SOV#39-Unforeseen Conditions Change Allowance

PROJECT: Truman Waterfront Park Project

FIELD CHANGE DIRECTIVE
No. 08

SK-003 - Coordination - Subgrade Work Plan

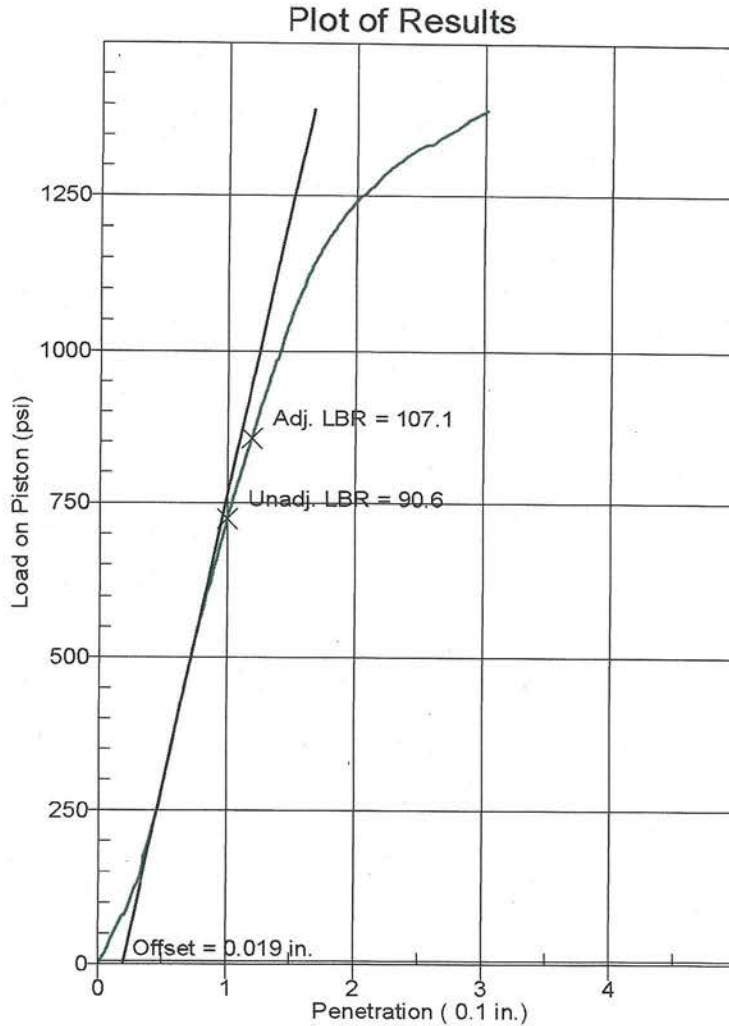
During the visit and Subgrade discussion last Monday, 23 May 2016, we agreed to proceed with LBR testing of the "Superblend" material. The result = unadjusted 90.6, please see the attached.

It was the professional opinion of the Soils Testing technicians with Concrete Analysis & Testing Laboratories, Inc. that the existing materials from the Fort Zachary entrance area to SSMH 1 were not suitable to achieve LBR40 through mixing based on previous site sampling and testing data results. To mix with the existing materials on site would risk inconsistent results and potential settling over time.

This proposal is for the removal / replacement of the 12" subbase with a suitable material as referred to in our discussions and per the Nutting Report, page 9, paragraph, Paving Areas. The attached sketch illustrates the quantity of materials and specific area of impact at this time.
